Repeated resetting of the Antenna Unit Processing (AUP) module due to high contact resistance of connector on Interconnection Board (ICB)

Artemis MK5 Engineering Note EN5-1

Photo 1

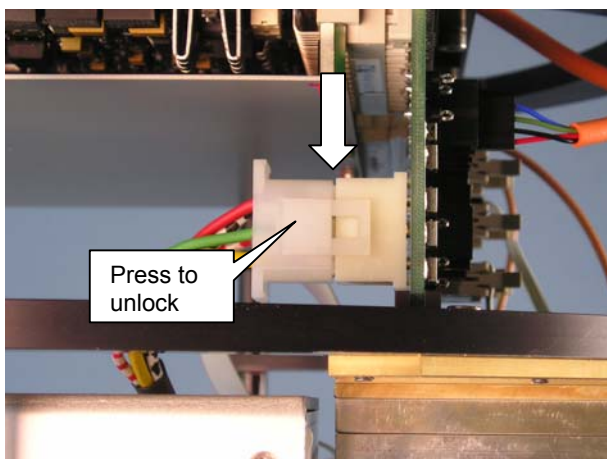
It has appeared that the 6-way connector used for the connection of the supply voltages from the power supply module A5PS to the Interconnection Board A5ICB – see photos below - may have a considerable contact resistance. If this is the case, this may cause the supply voltage of the Antenna Unit Processing (AUP) module to drop below the minimum voltage, upon which the AUP module will repeatedly reset itself.

1. Switch the Antenna Unit or Beacon Unit off (switch off the power to the unit).
2. Remove the bottom cover from the Antenna Unit or Beacon Unit.
3. Locate the white 6-way cable connector at the inside of the Interconnection Board (photo 1).

Photo 2

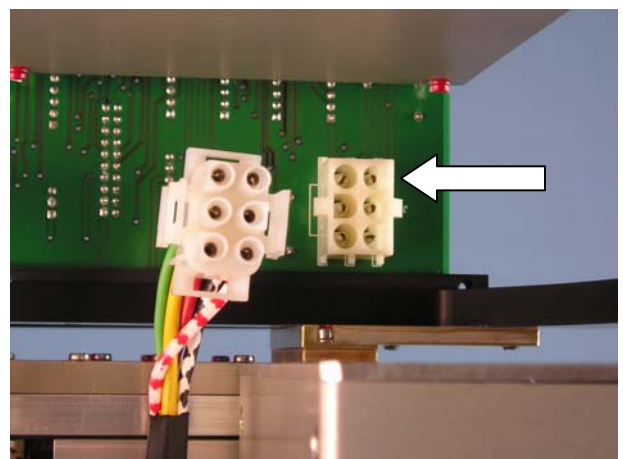
4. Press the locking mechanism on the connector with thumb and index finger and pull the cable connector from the Interconnection Board.
5. Take a small, sharp screwdriver and push it carefully in the slot of each of the six male contact pins (on the Interconnection Board) until the two halves of the contact pins are a bit more apart from each other (photo 2).
